Prototype SSR2 Jacketed Cavity Preliminary Design Review and Niobium Procurement Readiness Review - Report -

Document number: ED0009919 Rev. B

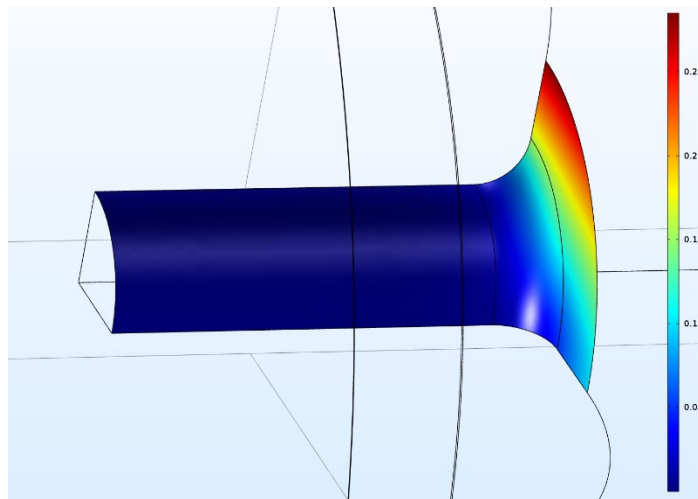
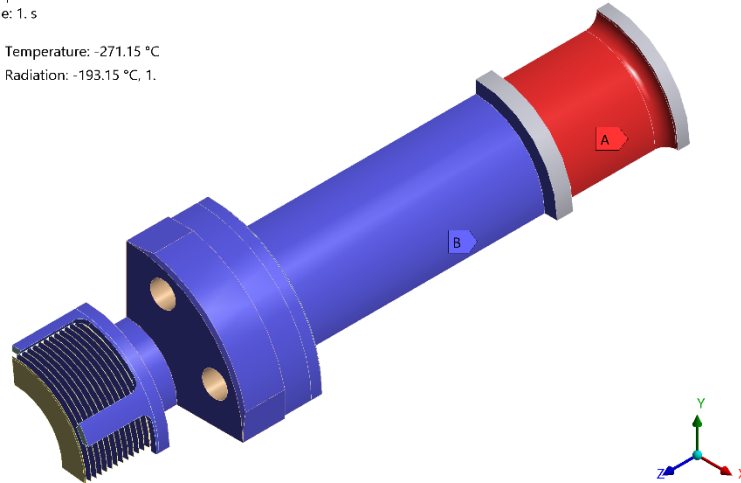
- b. Analyze and document the effect of the substantially increased length of the cavity beam ports (compared to SSR1), particularly from the point of view of thermal stability.
 - i. *RF dissipation in the beam tubes is negligible: both Magnetic field and Current are very low, one can look at the values from simulation.*

Surface current is negligible in the beam tubes: the EM field decays within the beam pipe blend.

Magnetic field (H) level is also negligible in SR2 beam tubes.

As a result the contribution to the cavity G factor of the beam pipes is insignificant being the surface integral of H^2 in the full cavity approx. $1.45E6$ times bigger than the tubes portion of the cavity.

Given all these consideration one can conclude RF heating of the beam tubes can be neglected, there it does not impose any limitations to the RF performance of SSR2 cavities.
